1CAN081403

SUBJECT: License Amendment Request
Update the Reactor Coolant System Pressure and Temperature and the
Low Temperature Overpressure Protection System Limits
Arkansas Nuclear One, Unit 1
Docket No. 50-313
License No. DPR-51

Description and Assessment of the Proposed Changes

FIGURE 3.4.3-1
RCS Heatup Limitations to 54 EFPY

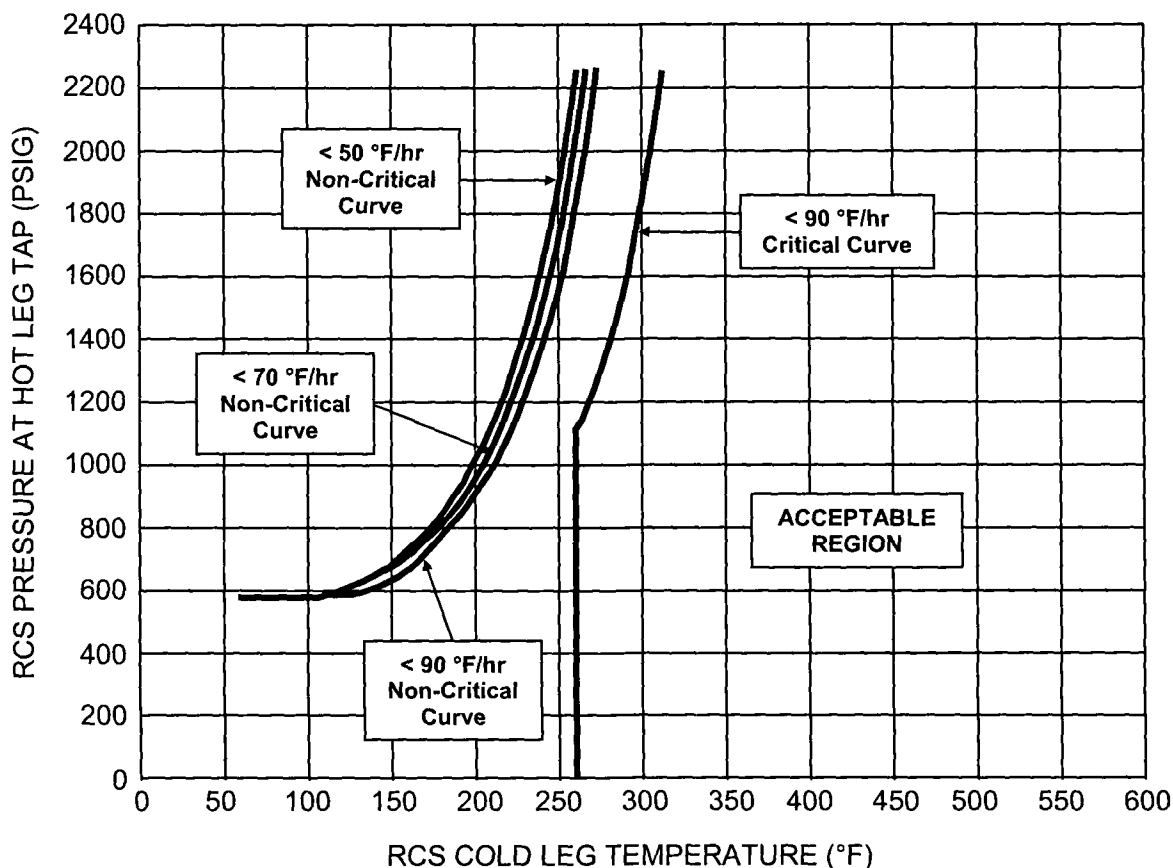
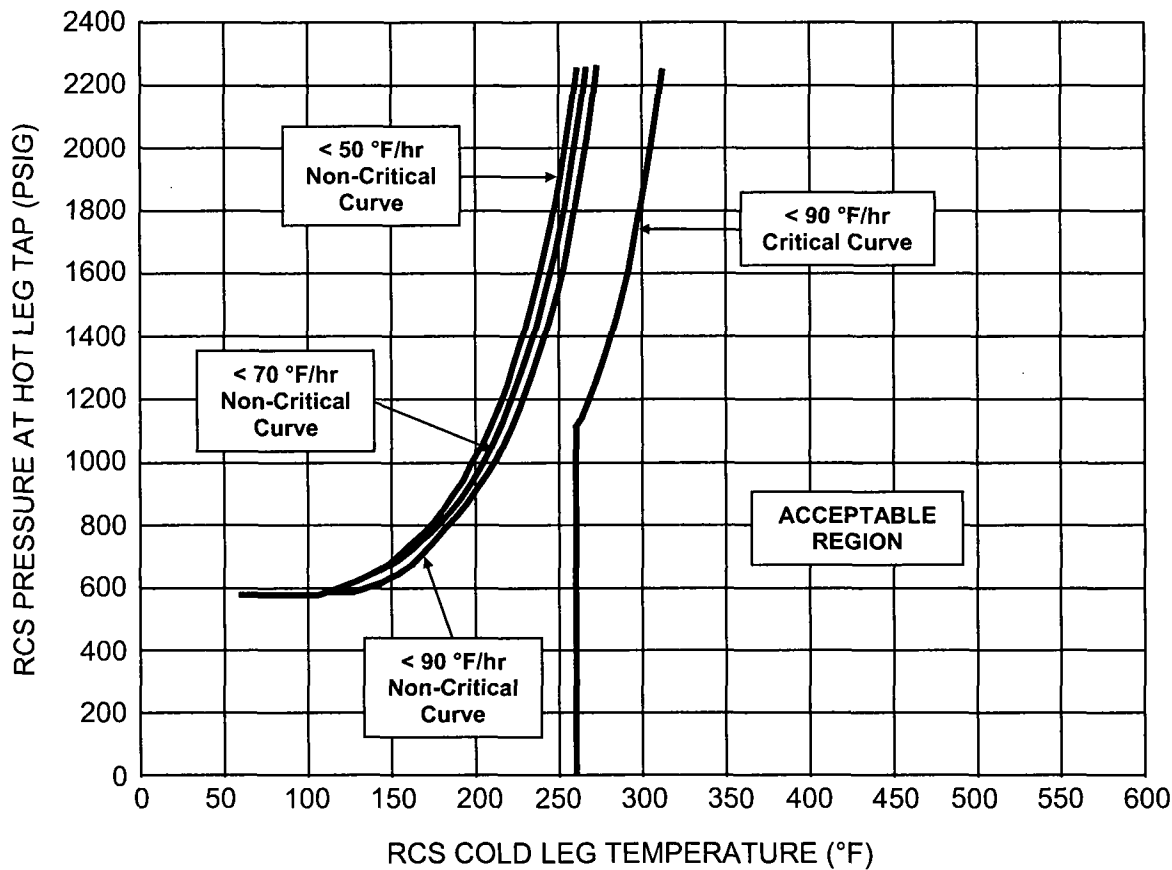
- TS Section 3.4.3 ("RCS Pressure and Temperature (P/T) Limits") is being revised to incorporate updated figures for P/T curves and reactor coolant pump restrictions. These figures have been recalculated to account for 54 EFPYs of plant operation.
- TS 3.4.9, "Pressurizer"; TS 3.4.10, "Pressurizer Safety Valves"; and TS 3.4.11, "Low Temperature Overpressure Protection (LTOP) System" are being revised to account for 54 EFPYs of operation. The changes include the electromatic relief valve lift setpoint being changed from 460 pounds per square inch – gauge (psig) to 563.8 psig. The enable temperature for this valve is being revised from 262 °F to 248 °F. These changes are as a result of the revised LTOP analyses and are consistent with the new P/T limits. Instrument uncertainty has not been included in these values.

<u>RCS TEMP</u>	<u>H/U RATE</u>
60 °F < T ≤ 84 °F	≤ 15 °F/hr _{HRR}
T > 84 °F	As allowed by applicable curve

<u>RCS TEMP</u>	<u>H/U RATE</u>
$60\text{ }^{\circ}\text{F} < T \leq 84\text{ }^{\circ}\text{F}$	$\leq 15\text{ }^{\circ}\text{F/hr}$
$T > 84\text{ }^{\circ}\text{F}$	As allowed by applicable curve

FIGURE 3.4.3-2
RCS Cooldown Limits to 5431 EFPY

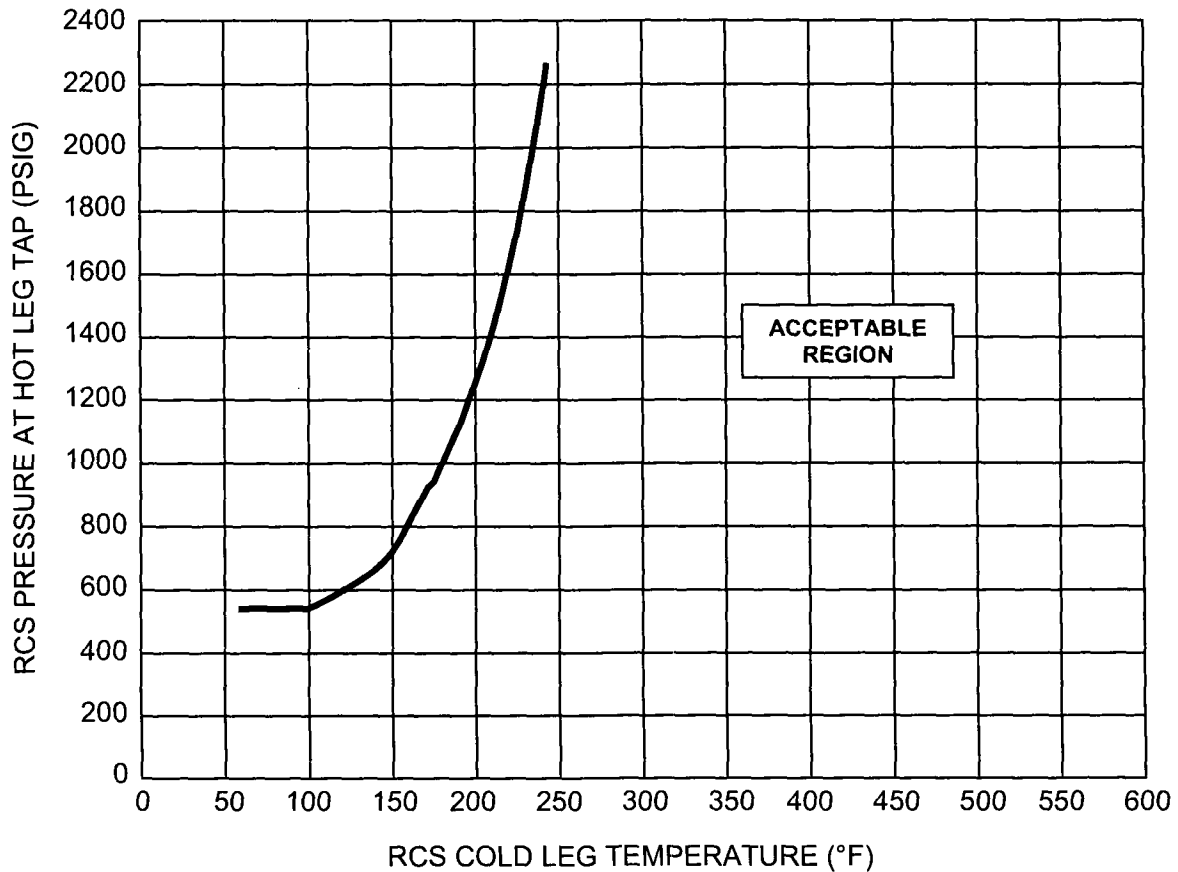
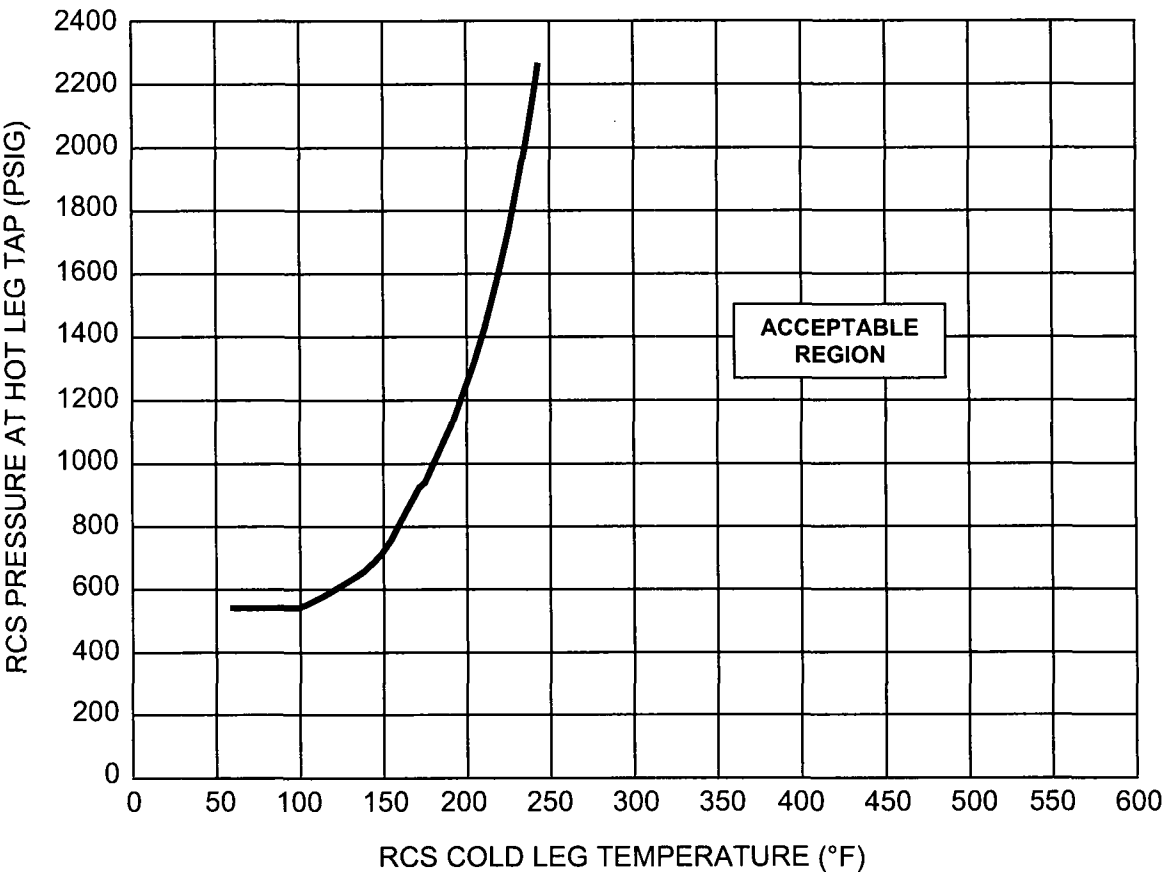
5. ~~If RCPs are operated $< 200\text{ }^{\circ}\text{F}$, then the RCS cooldown rate from $150\text{ }^{\circ}\text{F} \leq T \leq 180\text{ }^{\circ}\text{F}$ is reduced to $30\text{ }^{\circ}\text{F in 15 hours}$.~~

1. This curve is not adjusted for instrument error and shall not be used for operation.
2. A maximum step temperature change of 25 °F is allowable when securing all RCPs with the DHR system in operation. This change is defined as the RCS temperature prior to securing all the RCPs minus the DHR return temperature after the RCPs are secured. When DHR is in operation with no RCPs operating, the DHR system return temperature shall be used.
3. RCP Operating Restrictions:

<u>RCS TEMP</u>	<u>C/D RATE</u>	<u>STEP CHANGE</u>
$T \geq 280\text{ }^{\circ}\text{F}$	100 °F/hr	$\leq 50\text{ }^{\circ}\text{F}$ in any 1/2 hr
$280\text{ }^{\circ}\text{F} > T \geq 150\text{ }^{\circ}\text{F}$	50 °F/hr	$\leq 25\text{ }^{\circ}\text{F}$ in any 1/2 hr
$T < 150\text{ }^{\circ}\text{F}$	25 °F/hr	$\leq 25\text{ }^{\circ}\text{F}$ in any 1 hr
